# Appendix G

## Appendix G-1 Groundwater Specialist Response

COMPANY:	Rix's Creek Pty Limited		
ATTENTION:	John Hindmarsh		
FROM:	RPS Water		
DATE:	23 March 2016	JOB NO: WS00066E	DOC NO: 005c
SUBJECT:	Rix's Creek EIS - Supplementary Groundwater Information

Subject: Hydrogeological Advice on Issues Raised by DPI Water on the Rix's Creek Model

**Figure 1 : Location of Calibration Targets (Local to Site)**

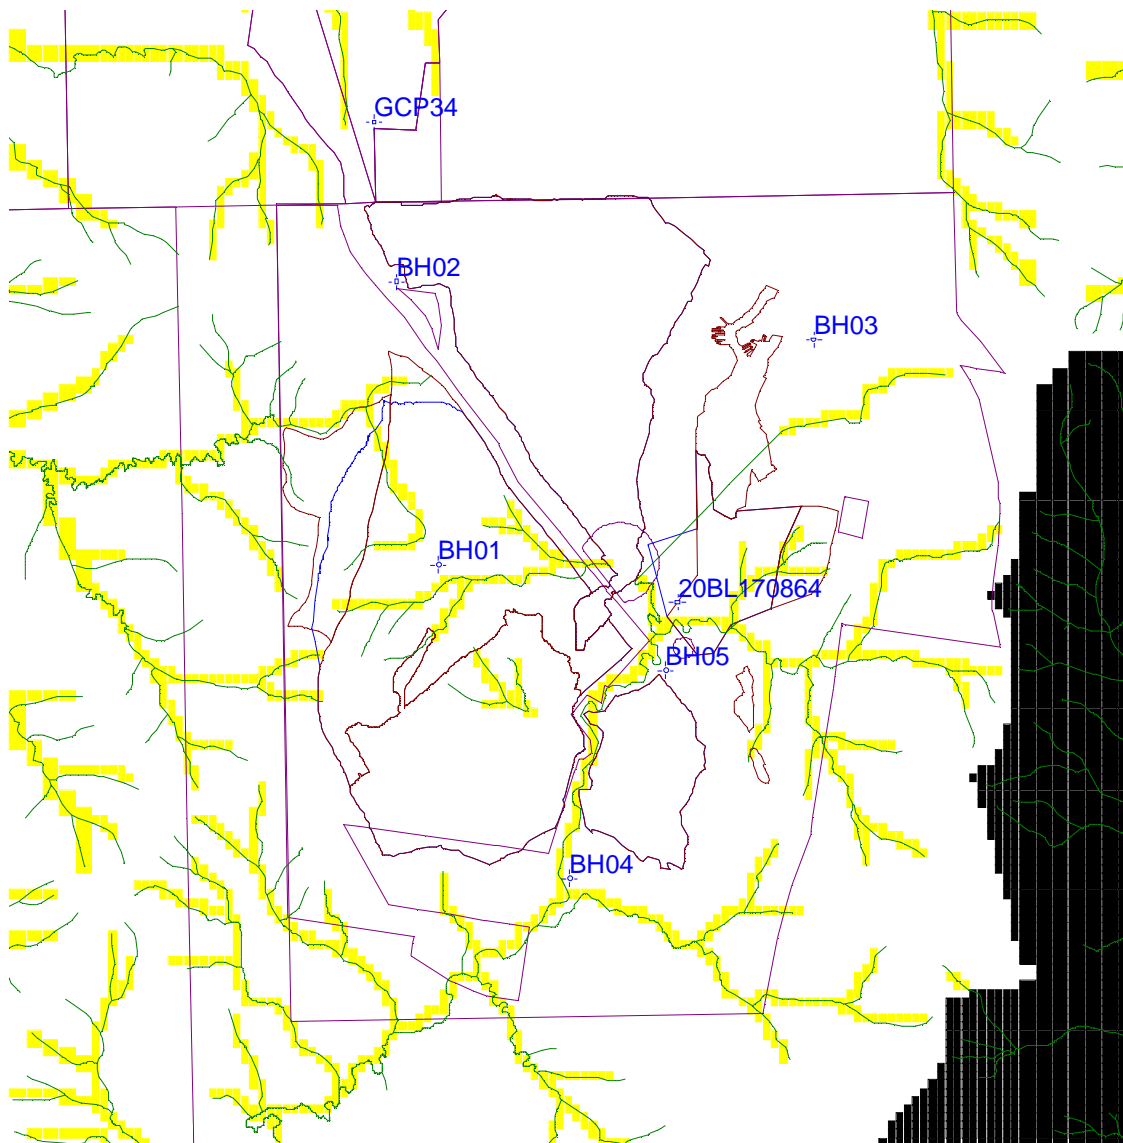
Issues	Response	Outcomes from Site Meeting – 21/01/16 (RPS)	Additional Information
	west.		
8. The calibration dataset type should be better described and it is unclear where the calibration points are situated as no legible map has been provided.	agreed	Provide map and description of calibration dataset.	Refer to supplementary groundwater information

The location of model calibration targets is presented in Figure 8.14.6 to 8.14.8 of RPS (2014) with respect to each layer. **Figure 1** below presents the same information, however, with all targets local to the site, presented on a single figure, regardless of which model layer they reside in. It is highlighted that the scale of the model domain is large so as to account for potential cumulative impact from the adjacent mining operations to the north, northwest and far southwest as well as the Hunter River.

**Figure 5 : Modelled Groundwater Elevation (mAHD) (Layer 11, April 2014 (SP185TS5)) – Current Calibration Model (RPS Run # 015a\_CAL-Apr14\_07a.gww)**

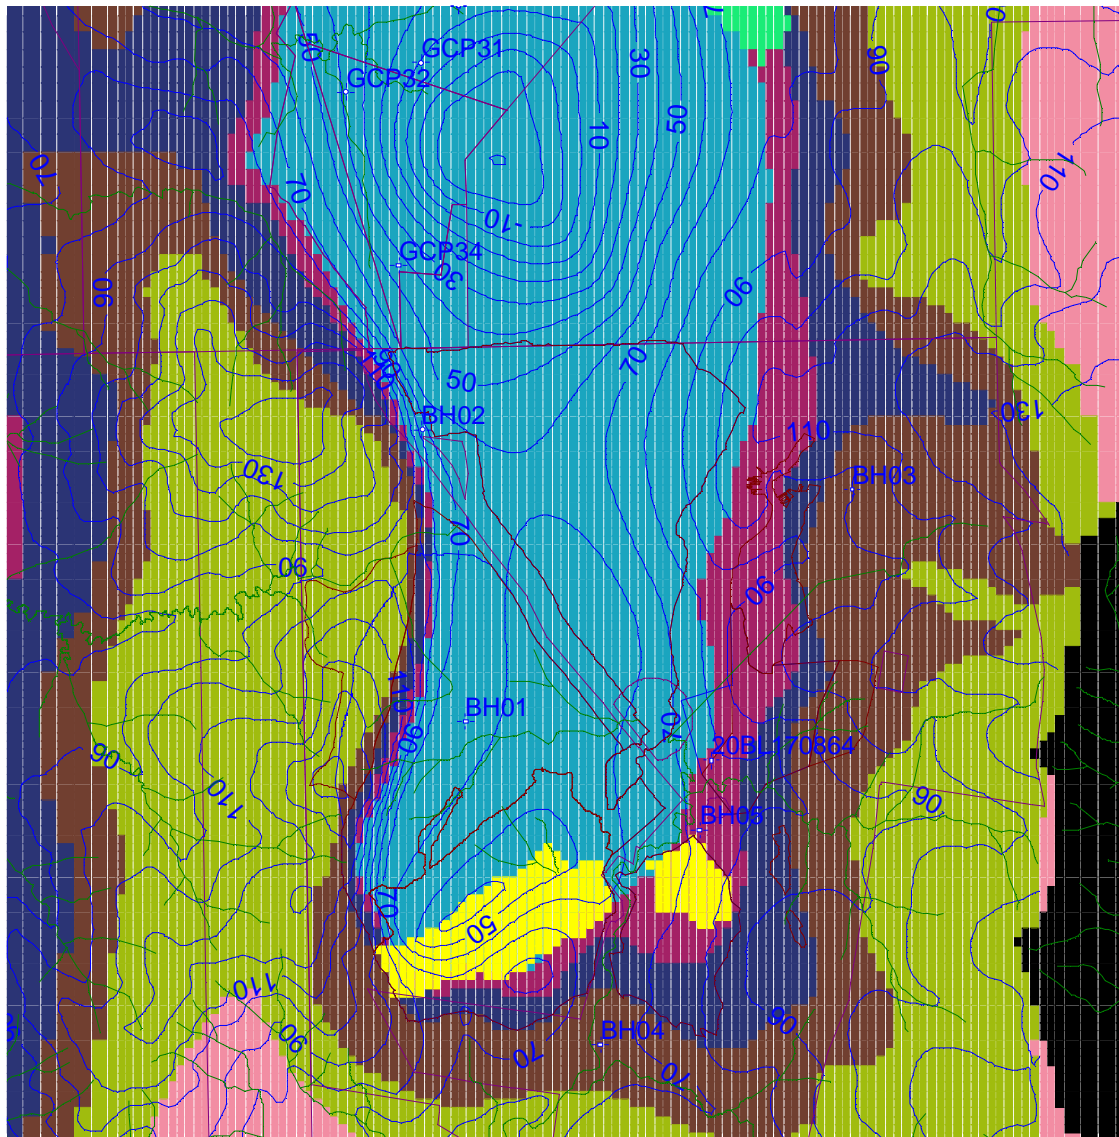
Issues	Response	Outcomes from Site Meeting – 21/01/16 (RPS)	Additional Information
	Agreed – output figures are poorly presented and units are missing.		
<p>2. The model was not calibrated. A scaled root mean squared error (SRMS) of 16% was achieved. The Australian Groundwater Modelling Guideline recommends ~10%. The calibration hydrographs were not legible so no analysis of the calibration was performed by DPI Water.</p>	<p>The model is calibrated and has an SRMS error of 16% as reported. This could have been improved by “disregarding” unfavorable calibration points that skew the results, however it was decided to keep in all available data.</p> <p>It should also be noted that by only utilizing data points within the syncline the calibration statistics would also have been improved.</p> <p>Mismatches in predicted versus observed values are typically the result of other localised stresses that are not included in the model.</p> <p>Agreed hydrographs are not clearly presented.</p> <p>Aside from the SRMS the model water balance was sound and provided reasonable results.</p> <p>For the potential risks posed by the development the calibration was deemed to be sufficient.</p>	<p>Provide calibration statistics for local monitoring points only to eliminate unknown regional stresses.</p> <p>Previous version of model with closer boundaries had a calibration of 9.6% SRMS.</p>	<p>Refer to supplementary groundwater information</p>

**Figure 5** presents the modelled contours of head (mAHd) in Layer 11 of the calibration model (RPS Run # 015a\_CAL-Apr14\_07a.gww), as at April 2014 (SP185TS5) together with the hydraulic conductivity zonation. It is noted that all calibration targets are displayed in **Figure 5** whereas, in the model, only target BH01 is located in Layer 11. Contour intervals presented in Layer 11 are 10m increment and the boundary condition (DRN cells) at the relevant timestep are displayed in yellow. As presented in RPS (2014), Section 8.5.5, DRN cells were used to represent progression of the open cut mine, based on mine landform surfaces (approximately 2 yearly during the calibration simulation).

From **Figure 5**, the influence of dewatering of the previous Integra operation and Pit 3 lead to development of a cone of depression with a north-south alignment. Target BH01 is located to the northwest of active mining area in Pit 3 and the drawdown is underestimated in the model. Target BH02 is located between Pit 3 and Pit 1, adjacent the hillside, where the local hydraulic gradient in the model is quite steep. As presented in RPS (2014), predicted impacts of continuation of mining at Rix's Creek are consistent with the conceptual hydrogeological model, namely hydrogeological impacts are constrained to the west, south and east due to outcropping of the various coal seams. **Figure 2** presents the hydrograph for monitoring location GCP34, which is located to the north of BH02. The fit to observation at GCP34, which is situated at the point where off-site impacts may propagate northward is closely matched.

**Figure 7 : Groundwater Elevation Hydrograph (mAHD) – Current Calibration Model (RPS Run ID. 015a\_CAL-Apr14\_07a.gvw)**

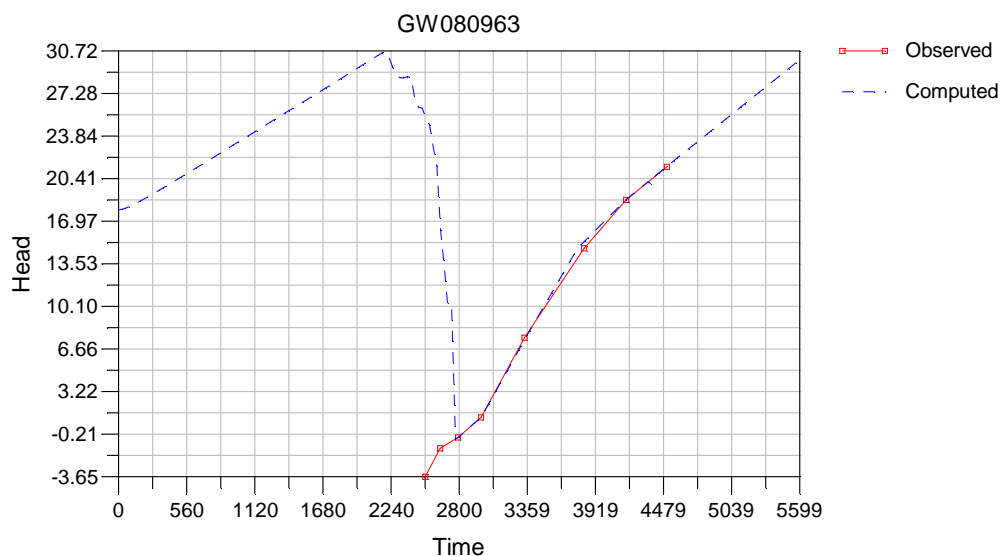
*Issue DPI Model 07) A general head boundary condition was applied to layers 3 and 4 of the model based on a linear extrapolation from bore GW080963. A conductance of 100 m<sup>3</sup>/day was applied to this fixed head. This feature provides an infinite supply of water into the model and it is uncertain whether this approximation is hydrogeologically justifiable in representing the long-term impact of mining activity in the south-west corner of the model domain. The effects that the feature may have on the model domain in maintaining water level elevations is unknown without inspection of the model.*

As stated in Section 8.5.4 of RPS (2014), the general head boundary was used to represent groundwater level history record at GW080963, which is located in the southwest corner of the model domain. The change in groundwater level at this location reflects the effect of Rio Tinto's Hunter Valley Operations site. **Figure 7** presents the modelled versus observed hydrograph at GW080963. To ameliorate the potential for an infinite supply of water to the model a general head boundary was used in place of a constant head boundary.
